**ARCHITECTURAL DESIGN ASSOCIATES, P.C.  
7501 'O' STREET, SUITE 105  
LINCOLN, NE. 68510**

**June 3, 2013**

**Nebraska Association of County Officials – Addition and Remodel  
Lincoln, Nebraska**

-----  
**ADDENDUM**

# DEMOLITION PLAN

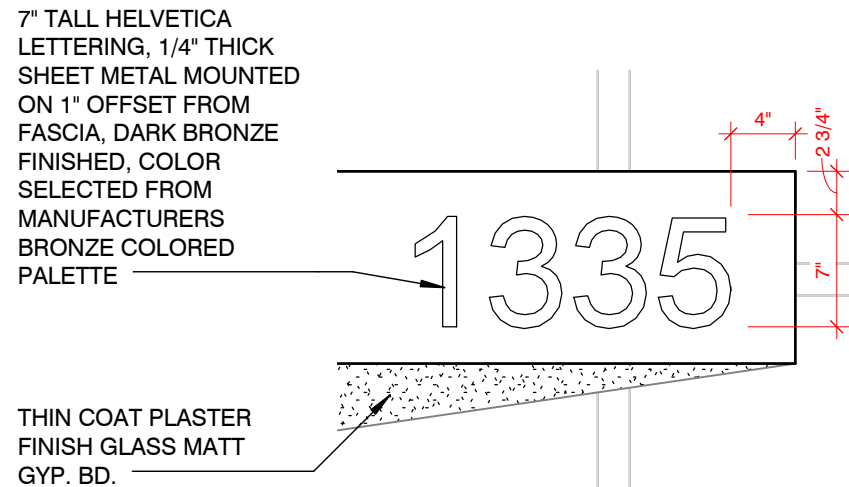
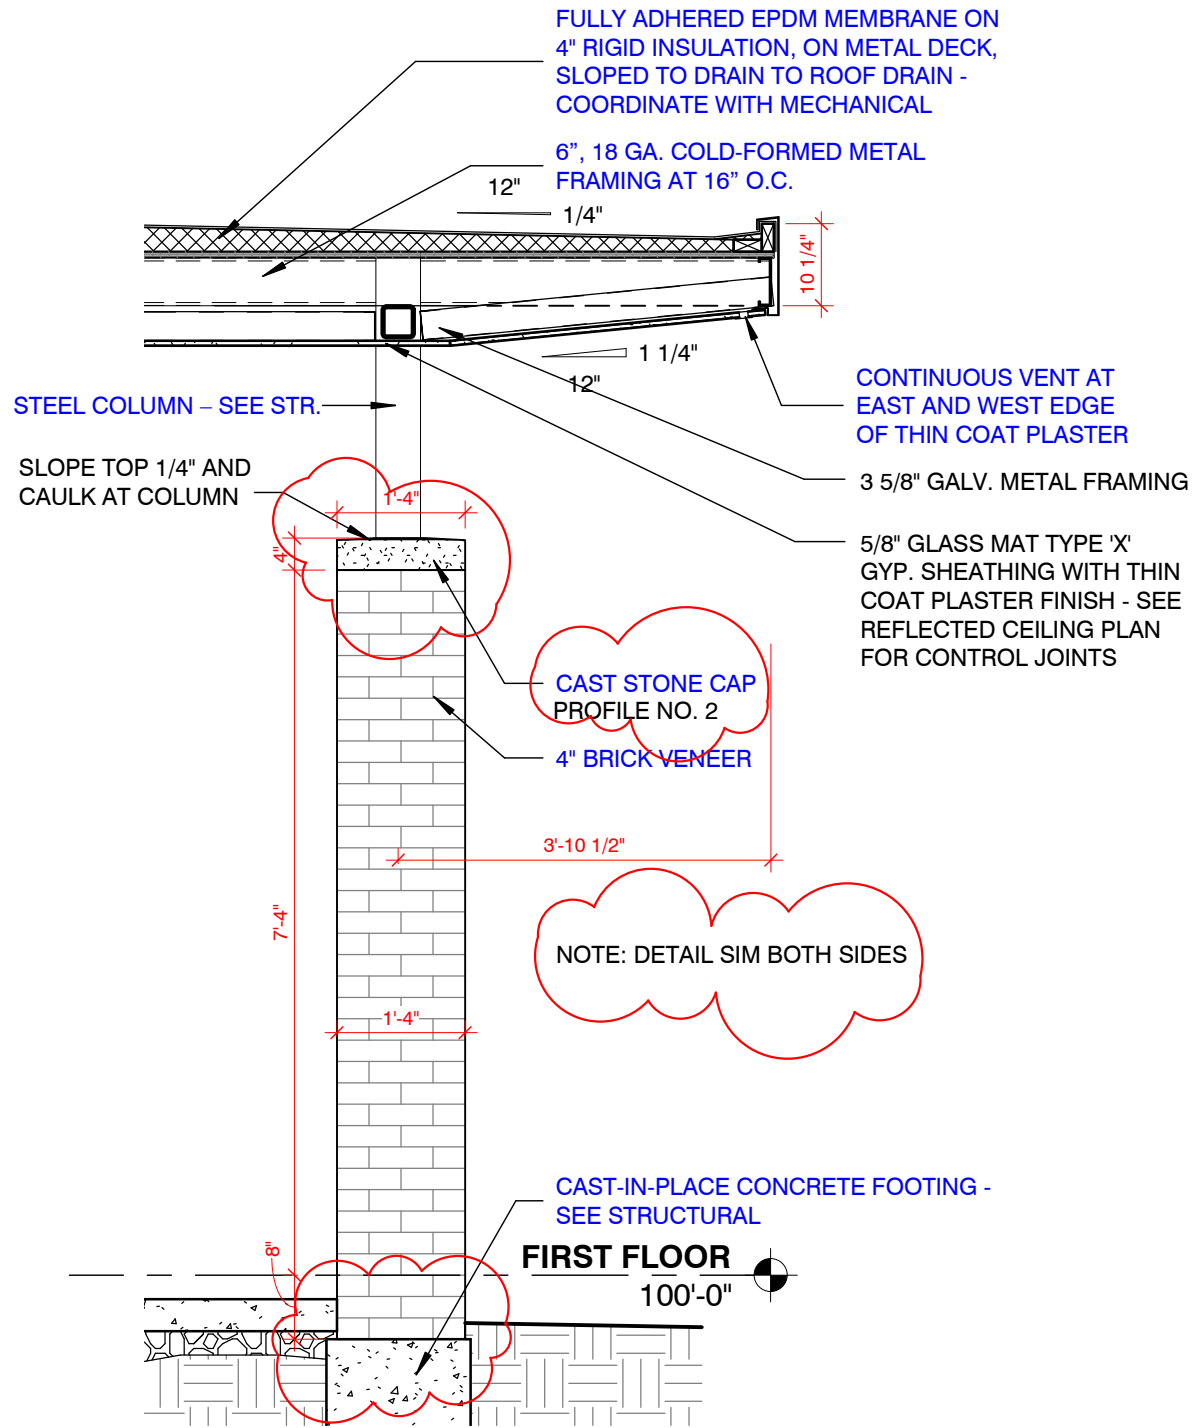
CONTRACTOR SHALL REMOVE AND SALVAGE OUTSIDE EXISTING AIR CONDITIONER UNIT COMPLETE, GIVE TO OWNER FOR RE-USE. DISCONNECT POWER, PROPERLY DISPOSE OF CHARGED FREON LINE (PER LOCAL AND STATE CODES). SEE MECHANICAL PLANS FOR NEW LOCATION.

| REMOVED OUTDOOR A/C UNIT COMPLETE, REVISED APPROXIMATE LOCATION OF EXISTING SANITARY SEWER | 06/03/13 | REGA |

**2** DETAIL - LETTERING  
 AD1.1 1" = 1'-0"

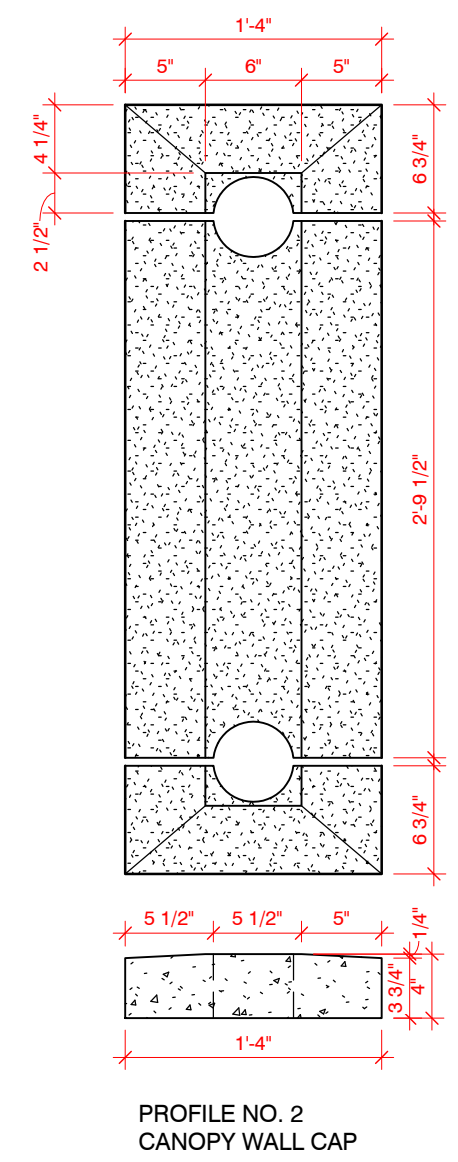
- A. 3 NORTH ELEVATION Add note “SEE AD1.1\2 FOR SIGNAGE DETAIL”
- B. GENERAL NOTE Add note “SEE AD1.1\3 FOR CAST STONE TRIM PROFILES”

**1** REVISED DETAIL - CANOPY SECTION  
 AD1.1 1/2" = 1'-0"

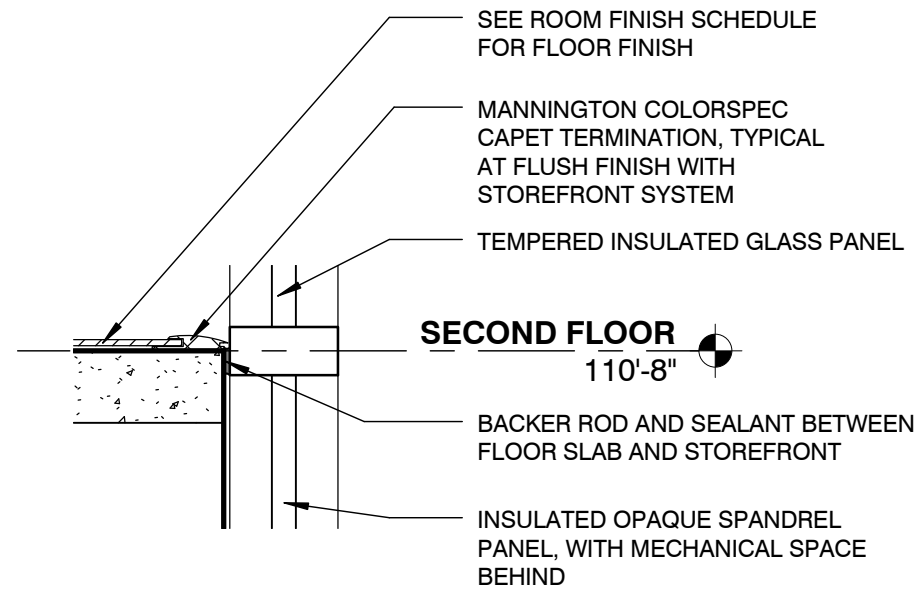
- D. 7 DETAIL – CANOPY SECTION Delete detail in its entirety and replace with attached detail AD1.1\1

**1** DETAIL - FLOOR JOINT AT NEW STOREFRONT  
AD1.2 1 1/2" = 1'-0"

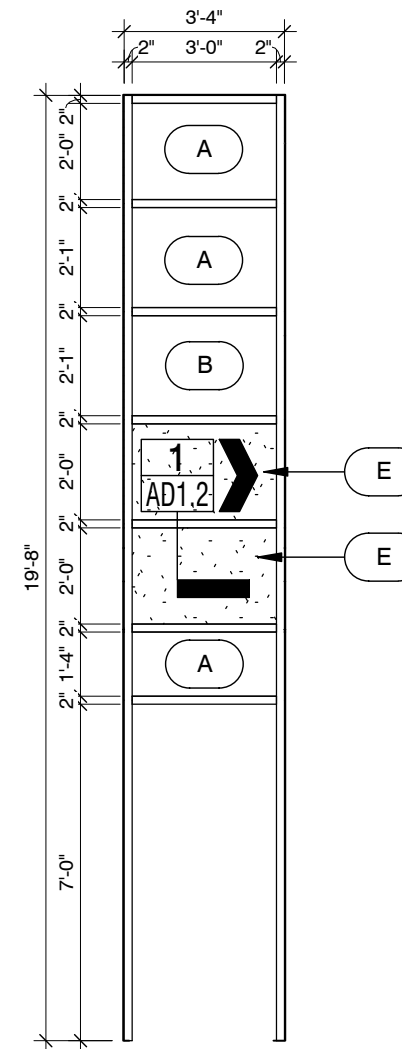
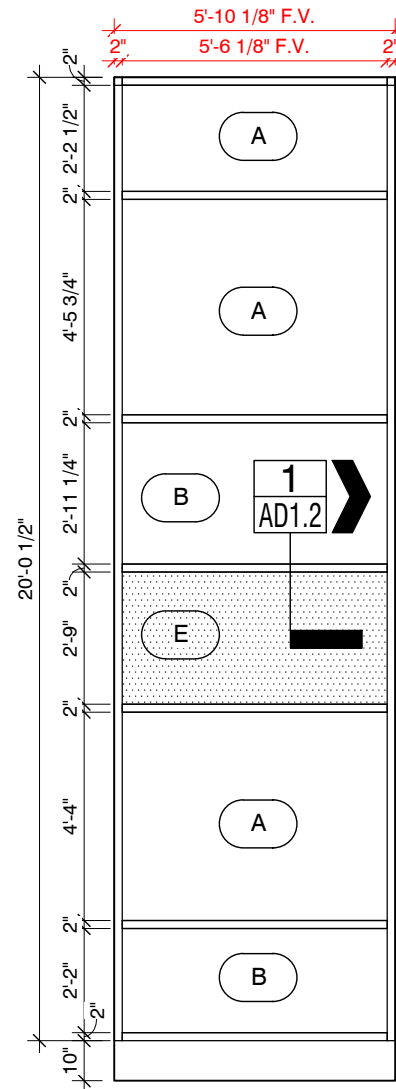
- A. 2 WALL DETAIL – FULL STOREFRONT Add note “SEE AD1.2\1 FOR REVISED DETAIL AT SECOND FLOOR BASE MULLION, COORDINATE WITH AD1.2\2”

# FIRST FLOOR DEMOLITION

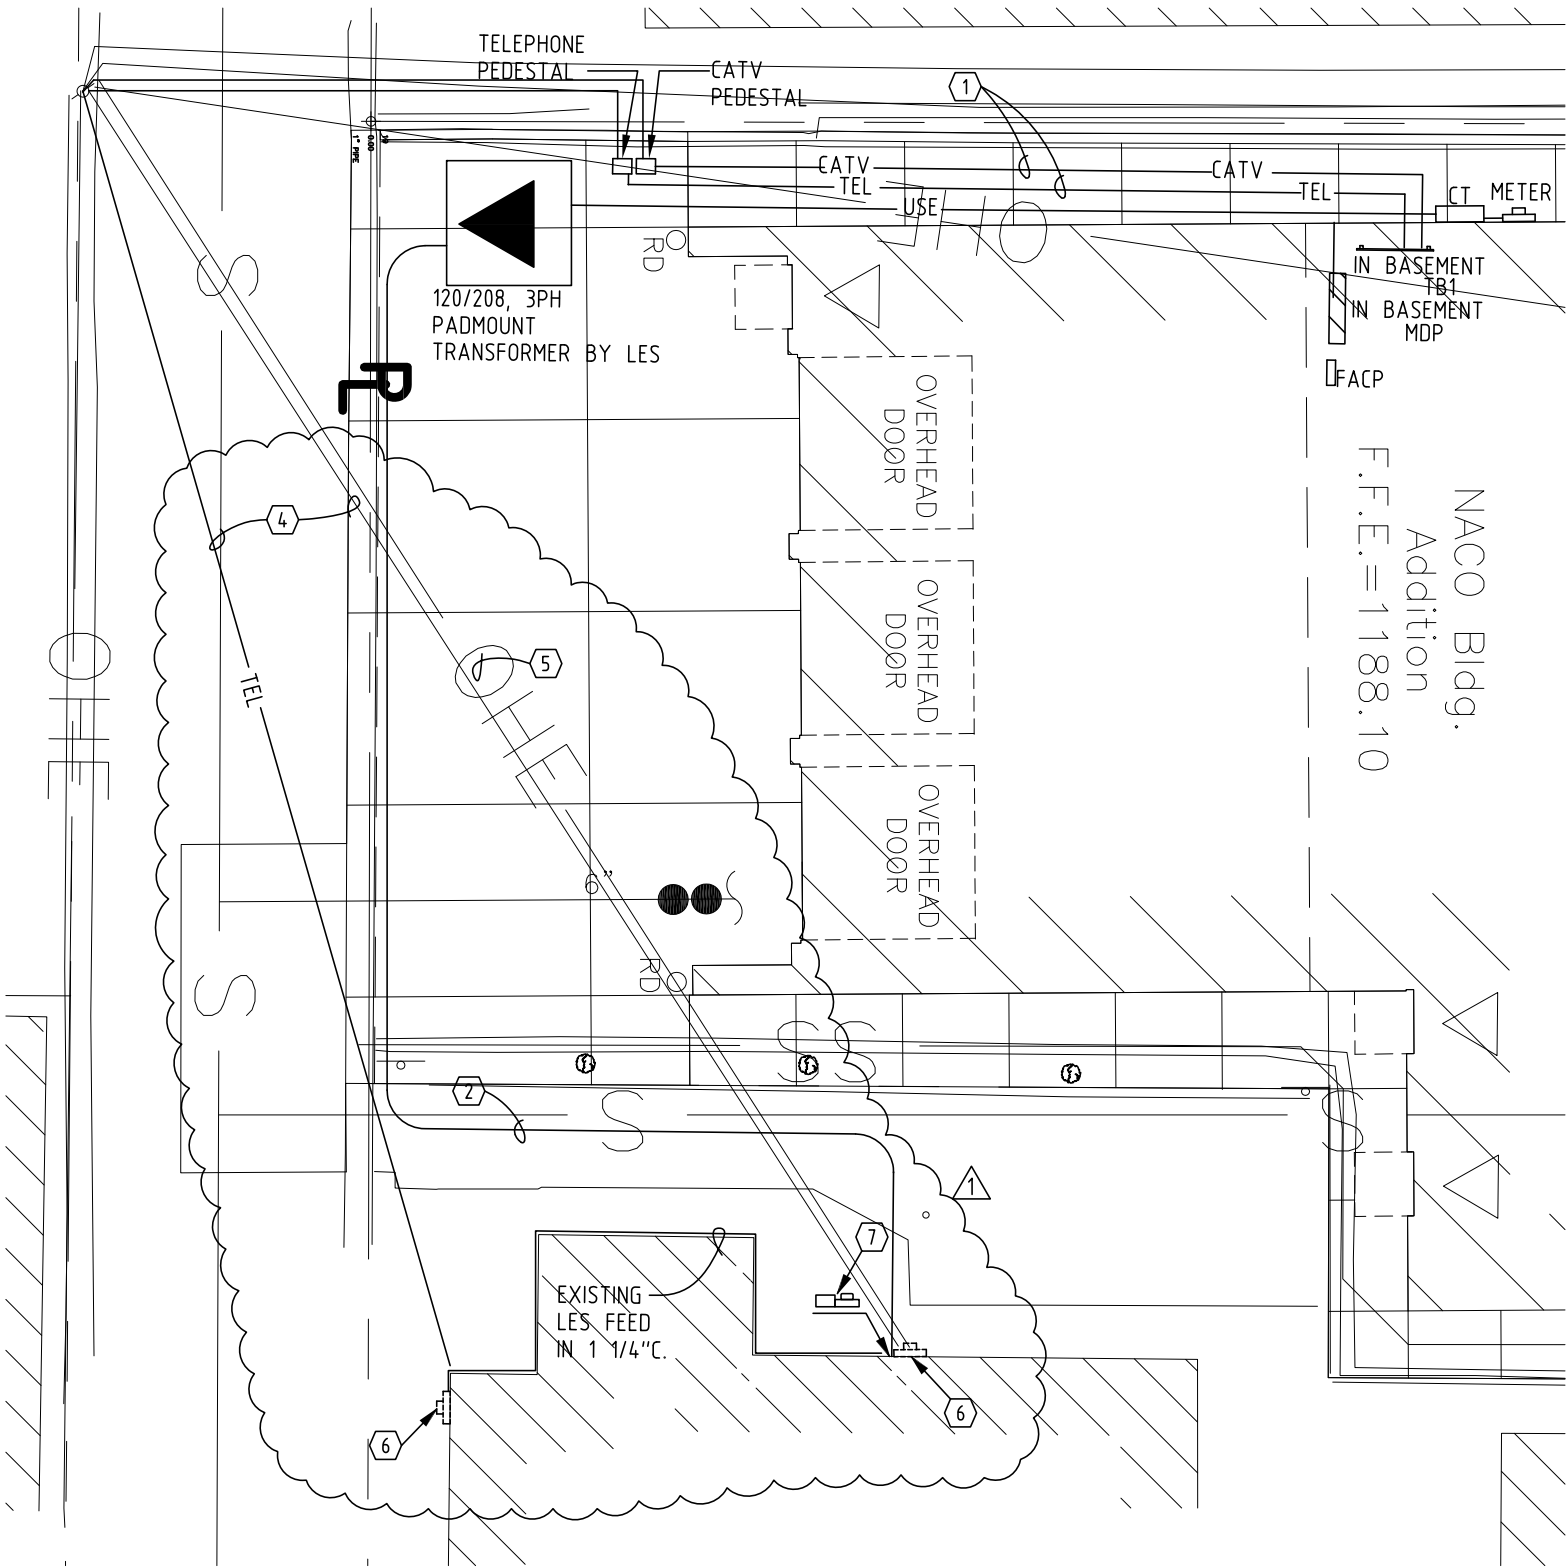
#### **A. Refer To Attached Sheet ED1.1 (1of1)**

- 1) Add Revised Notes.

**1 ELECTRICAL SITE PLAN**  
 E2.0 1" = 10'

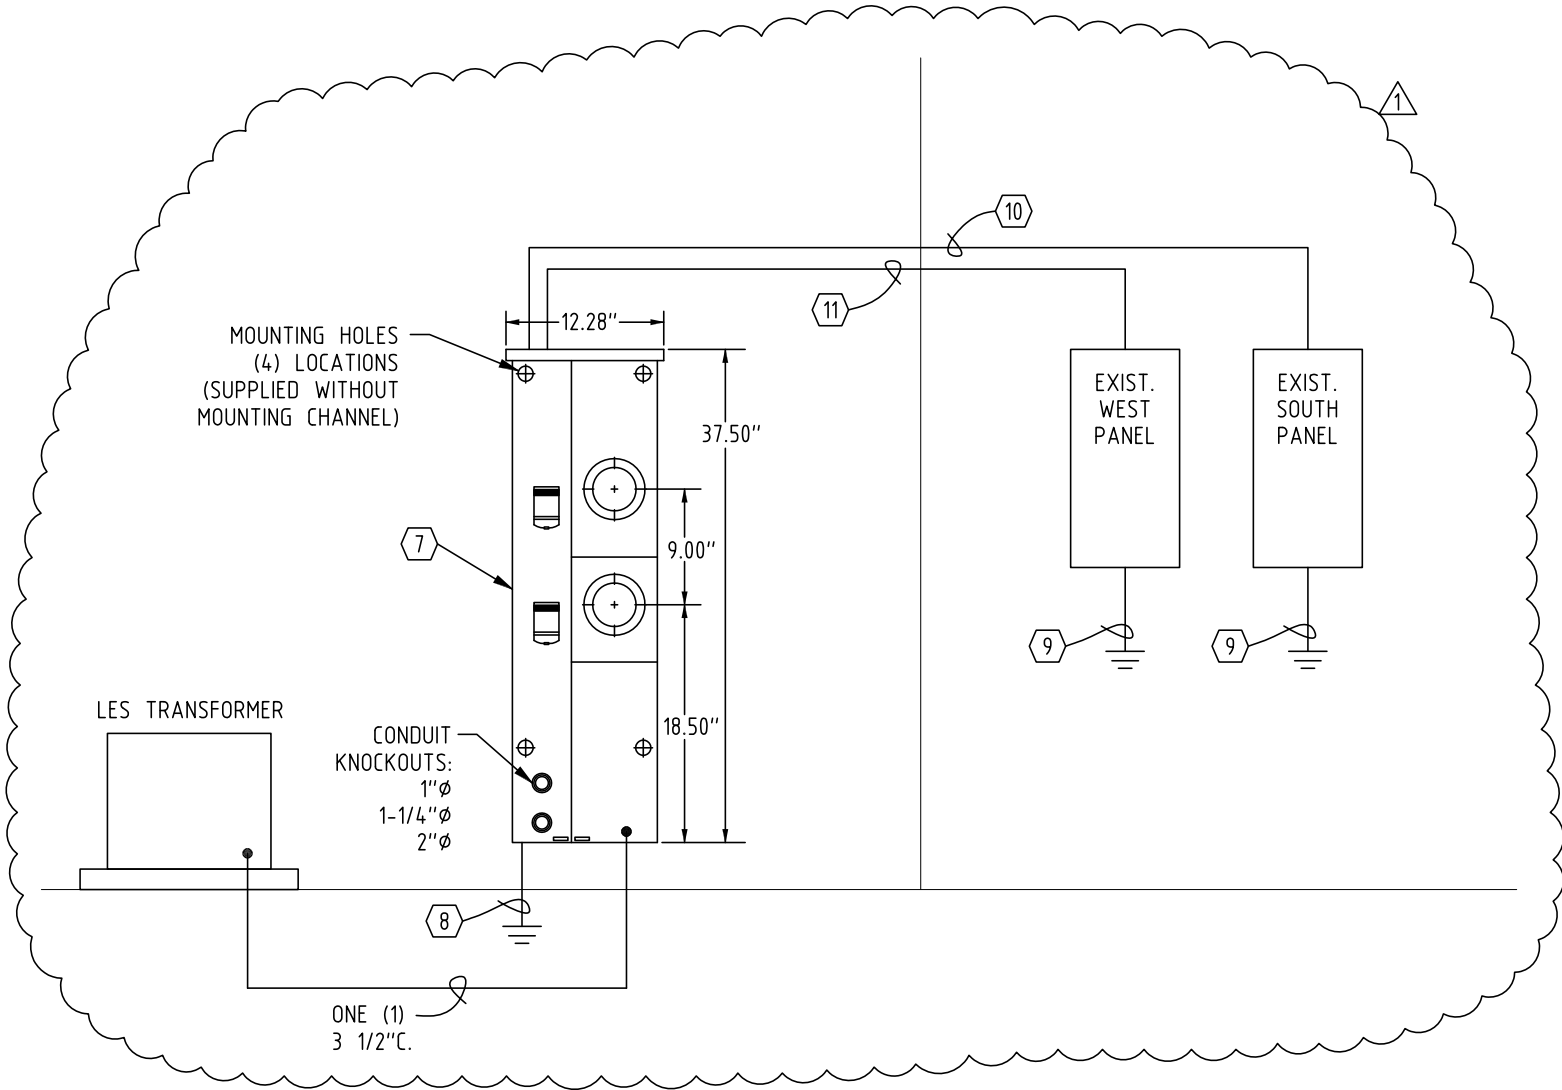
#### **C. Refer To Attached Sheet E2.0 (1 thru 3)**

- 3) Add Revisions to Electrical Site Plan.
